PA-257577

Product Advisory

Packaging update for NICs to consolidate labeling.

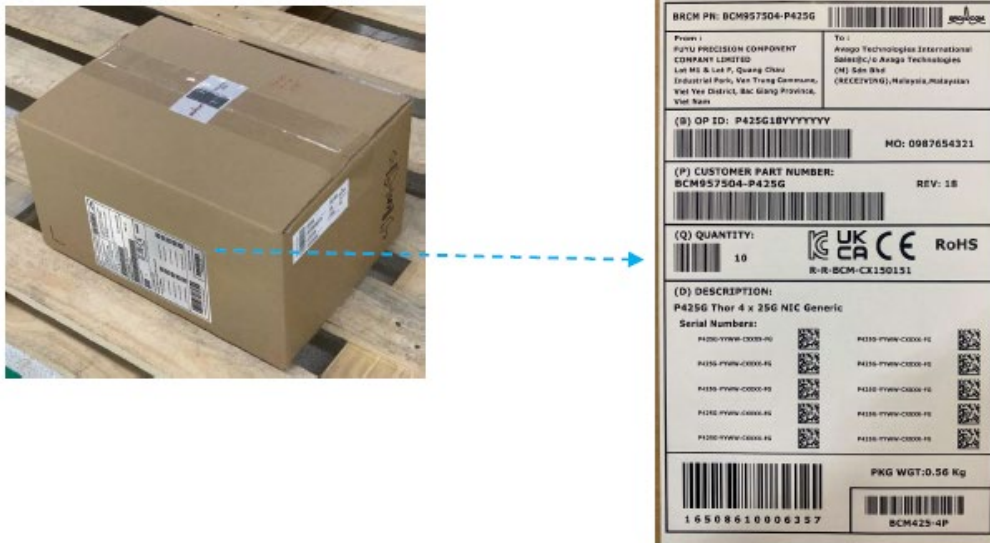
The NIC Serial Number and Carton ID labels will be consolidated into the Bulk ID label.
